SUBJECT: **Addendum #3 – I-15 La Mesa Nisqualli Interchange Project, San Bernardino County, in the City of Victorville, California, and SANBAG Contract No. C12010**

Addendum No. 3 is hereby issued to the following documents for I-15 La Mesa Nisqualli Interchange project in San Bernardino County, in the City of Victorville, California.

**ADDENDUM NO. 3
EXHIBIT 2**

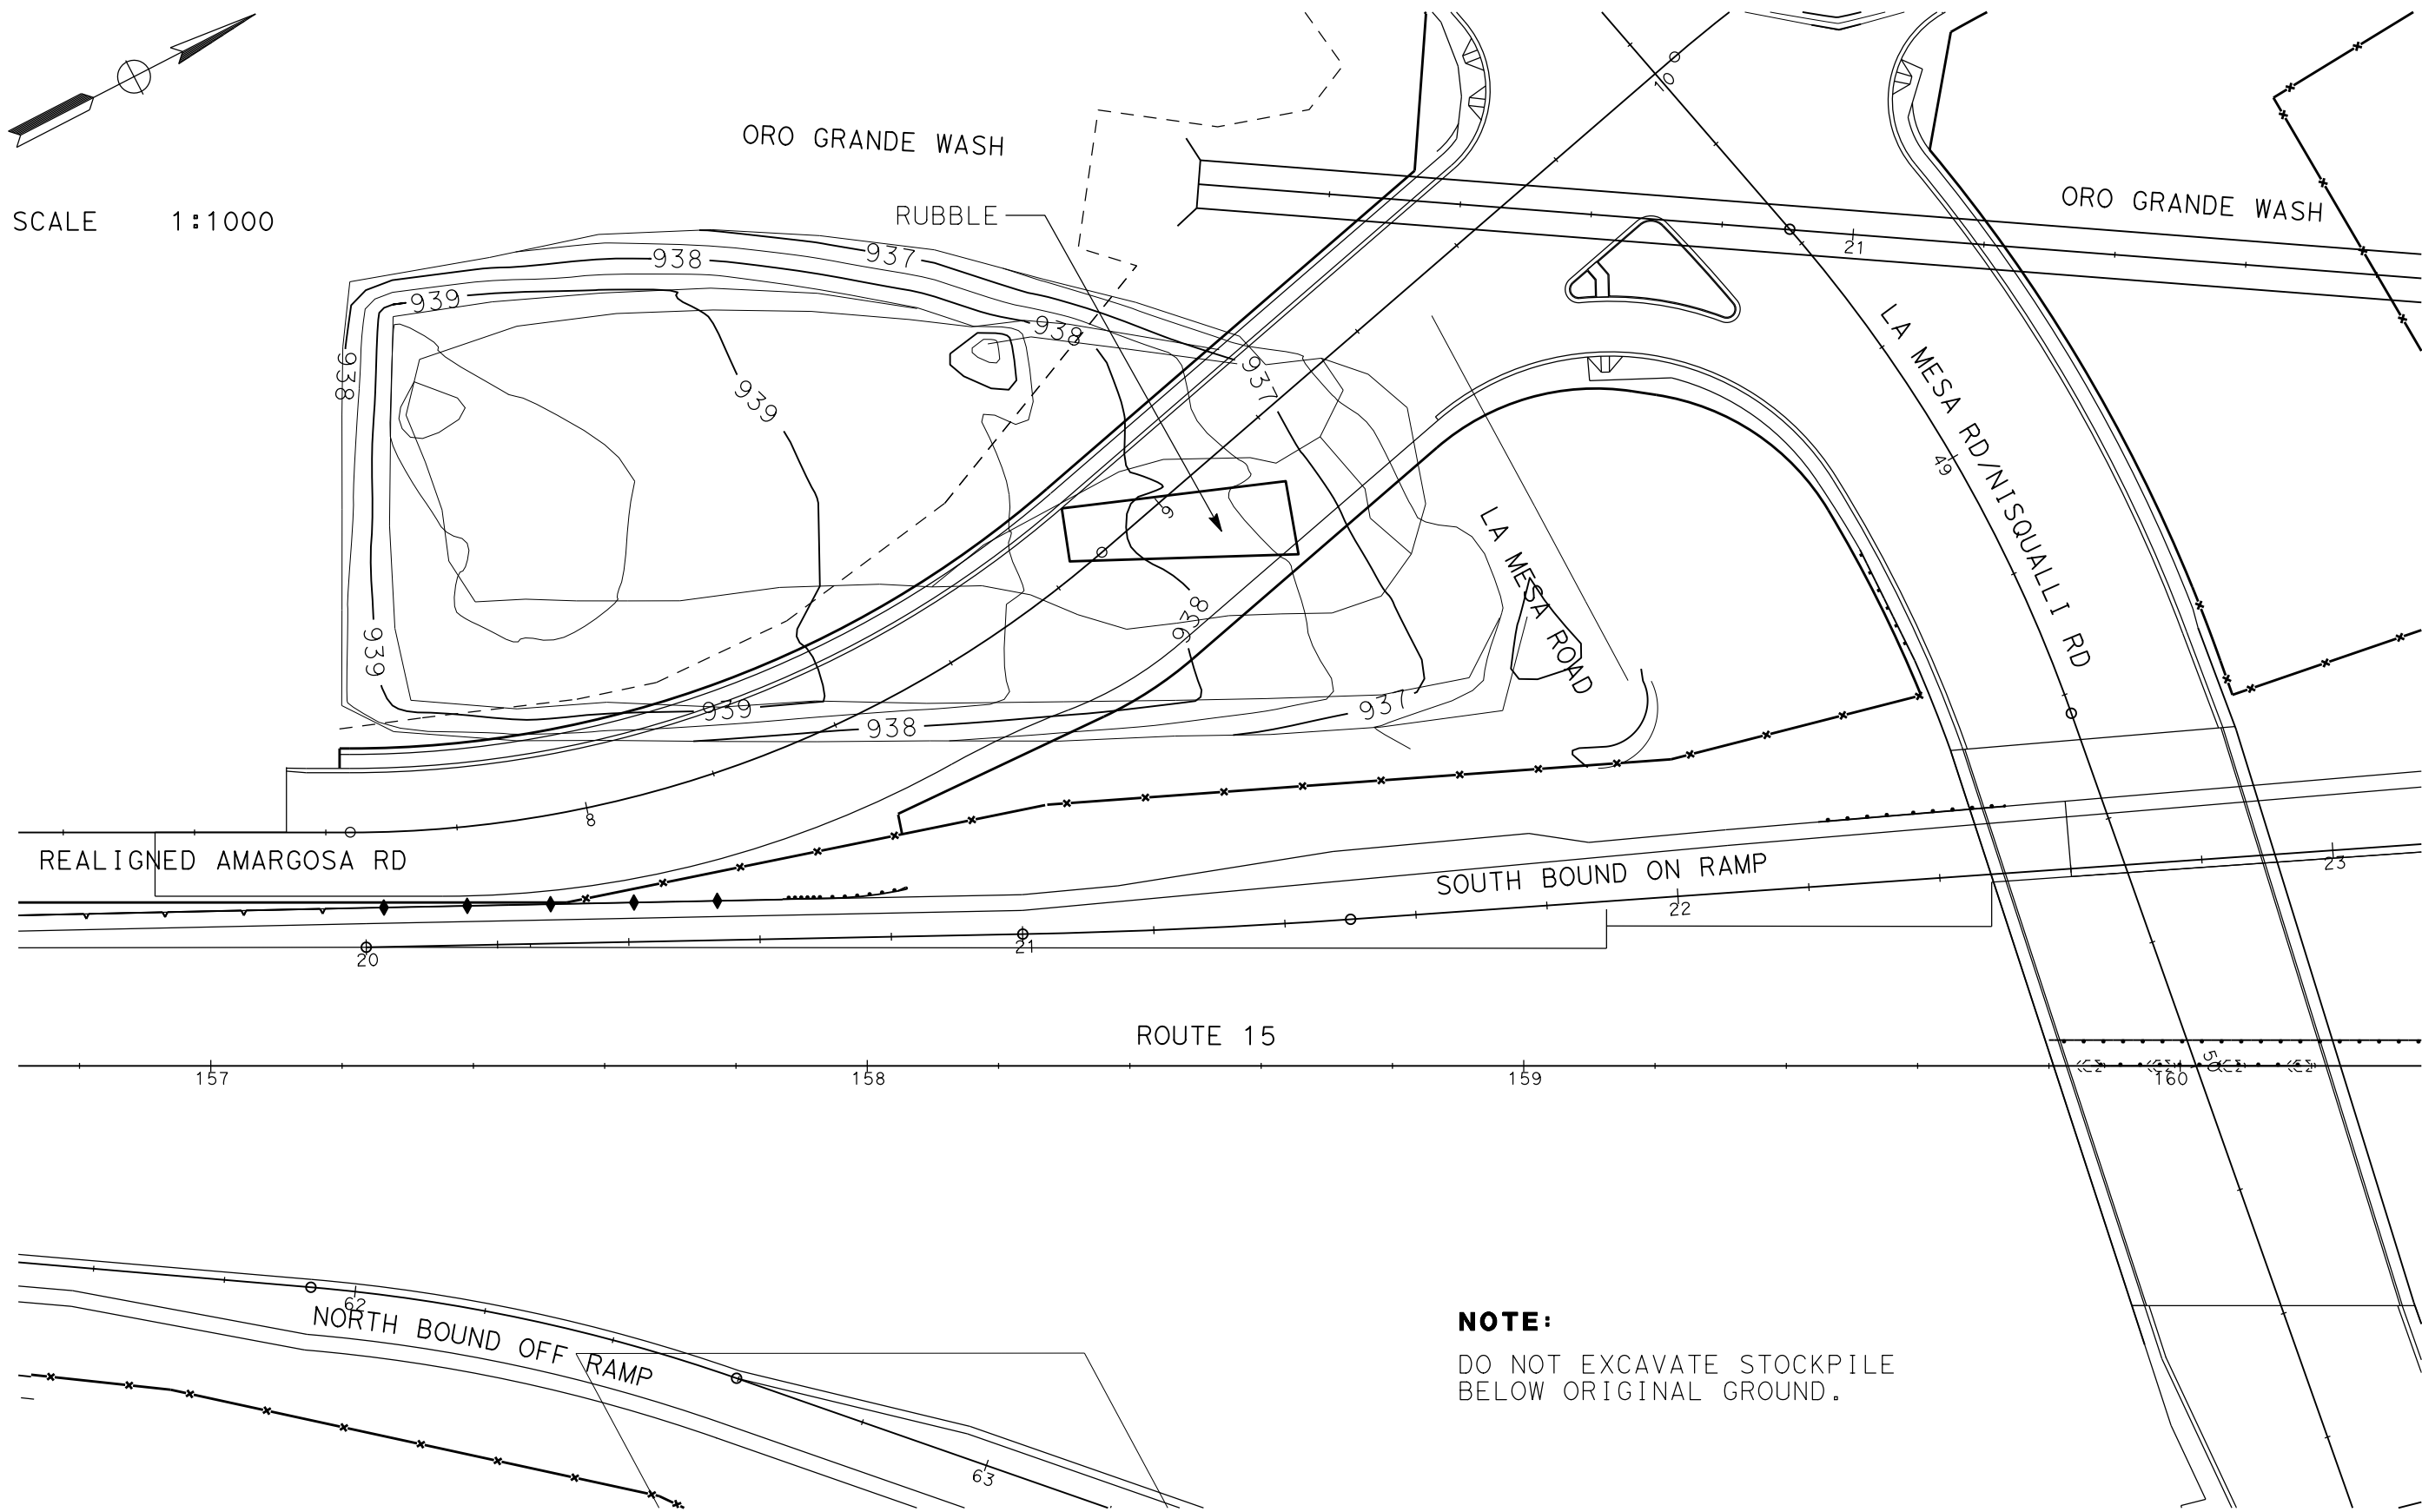
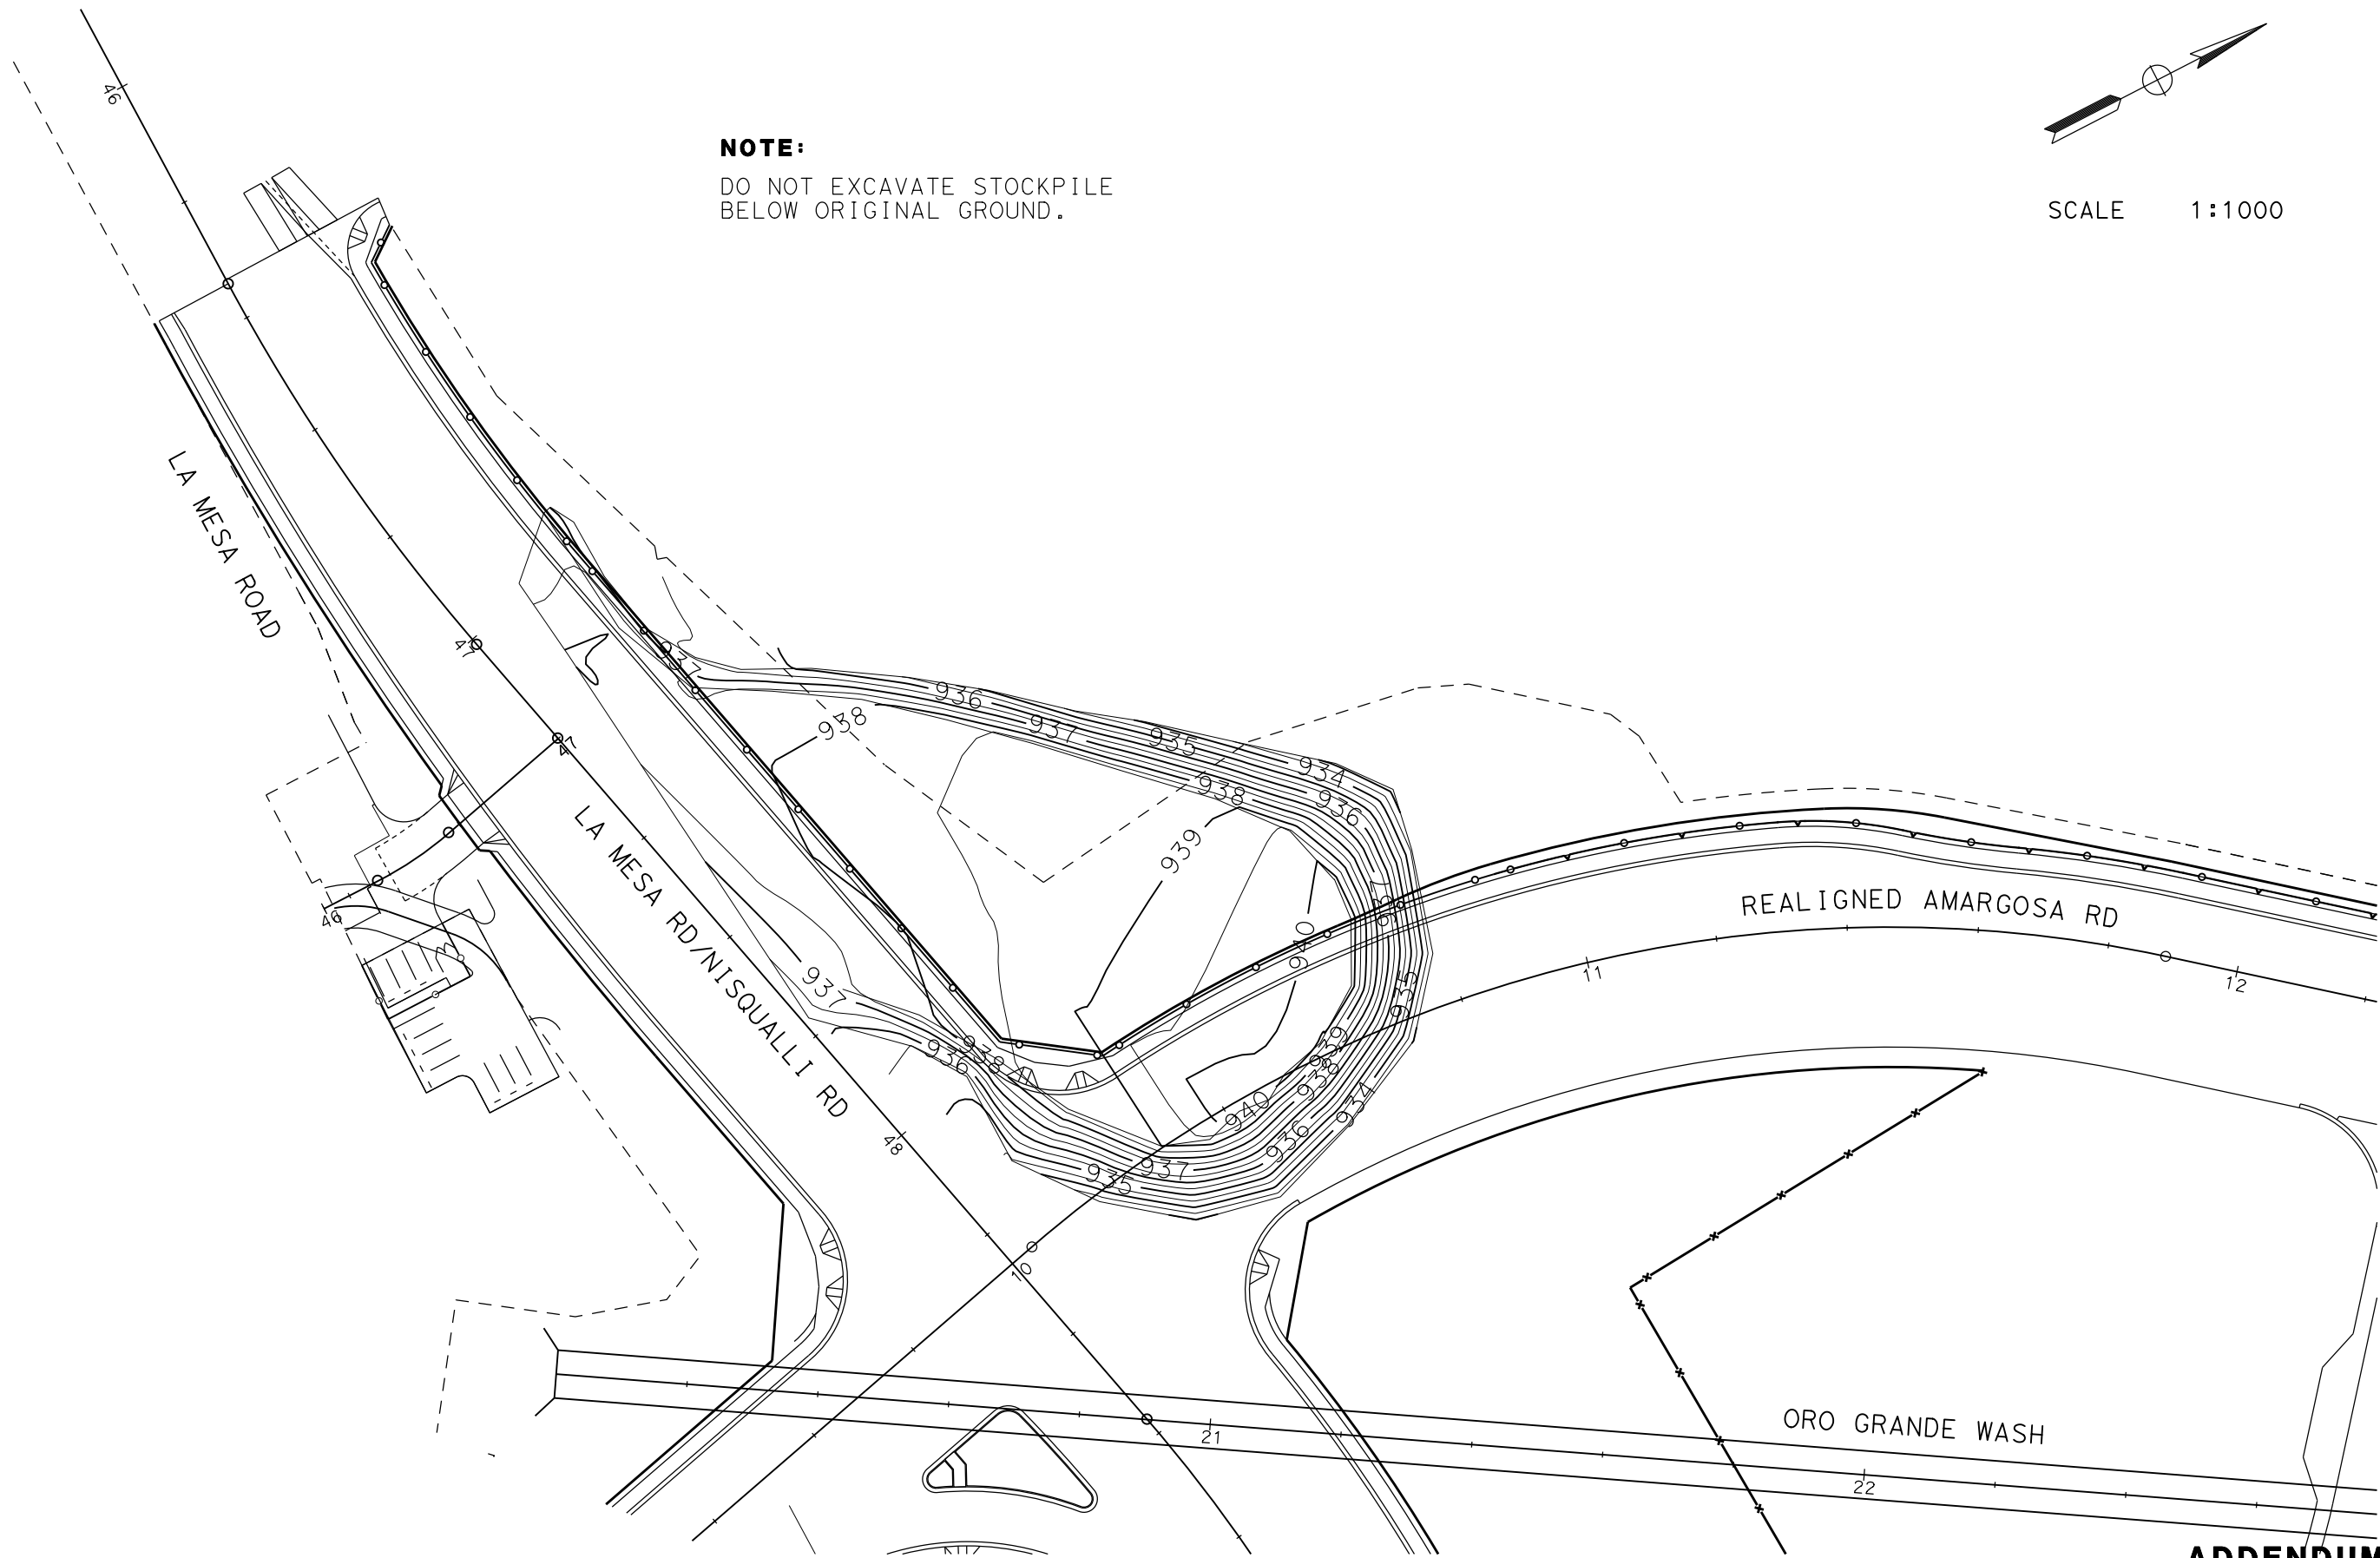
7. In Plan Set A, Add Addendum # 3, Exhibits 1, 2 and 3 “Existing Stockpile Locations”. Existing stockpiles are provided as “Local Borrow”. These exhibits depict corrected contours of existing ground compared to the surface levels reflected in the plan sheet contours. Local Borrow sites include “Oversized Rubble”

27. Question: Is it allowable to bury, within the embankment, the existing rubble consisting of broken AC and Concrete located at the SW corner of La Mesa/Amargosa Road?

1. As noted in **revised Table on Sheet Q-1 (Addendum # 3)** in the Bid documents, Agency has stockpiled approximately **87,300 m³** of soil material at various locations within the project site. Locations are visible on the site. A sketch showing the location of the dirt stockpiles is provided in provided in **Addendum # 3**. Stockpiled material includes broken concrete and asphalt.

Response: See Material Handout – Addendum # 3. Oversize rubble cannot be buried on site.
